CLOVERLEAF SUBDIVISION

LOCATED IN THE NORTHEAST QUARTER OF SECTION 23 AND THE NORTHWEST QUARTER OF SECTION 24, TOWNSHIP 11 SOUTH, RANGE 67 WEST OF THE 6TH PRINCIPAL MERIDIAN, COUNTY OF EL PASO, STATE OF COLORADO
PRELIMINARY PLAN

PRELIMINARY PLAN

Prelim Plan_v5-redlines.pdf Markup Summary

CROSS SECTION - WALTERS POINT

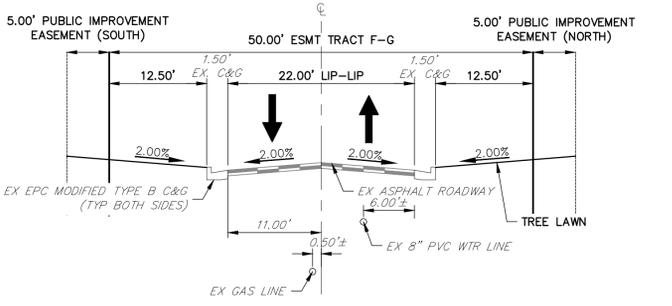
Remove. This section has been revised to a standard urban local road cross section.
